**CITY OF TACOMA**  
**Public Works Engineering Division**

**ADDENDUM NO. 2**

**REVISIONS TO:**  
**Request for Bids Specification No. PW20-0193F**  
**SOUTH 19TH AND CLAY HUNTINGTON**

## SIGNAL DETAILS - POLE SCHEDULE

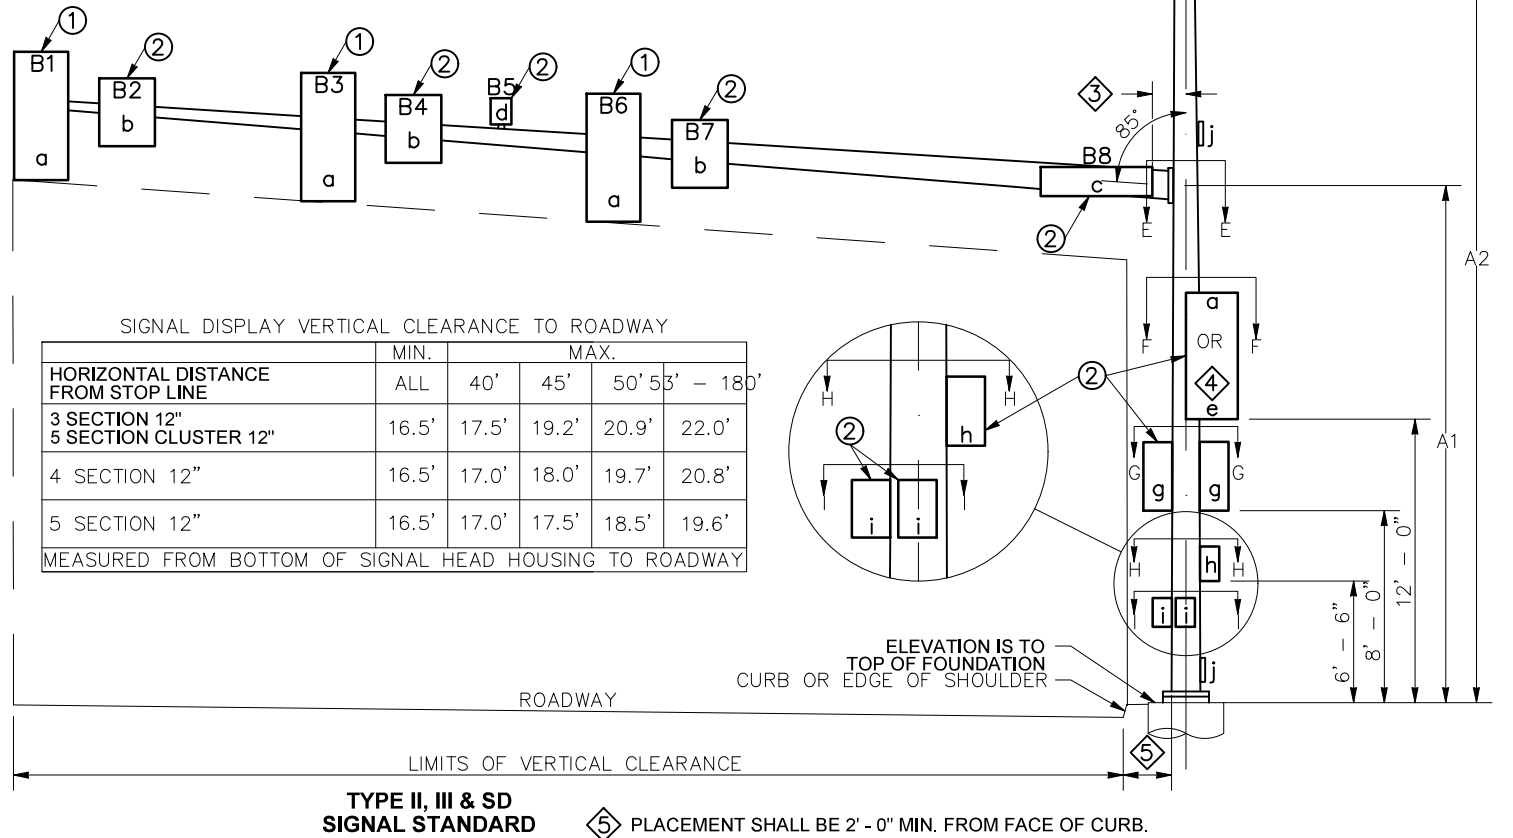
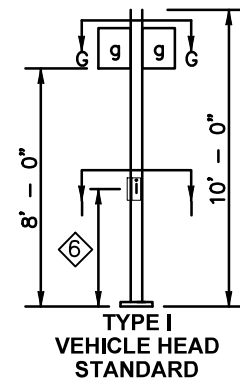
**2. Would you please clarify the mounting heights of the luminaire arms for poles #6 and #10, as the construction notes call out for both to be 30' mounting heights, whereby the traffic signal detail chart shows them both to be at 40'. What dimension will actually be required for both?**

See updated plan sheets SG-1 and SIG-3.
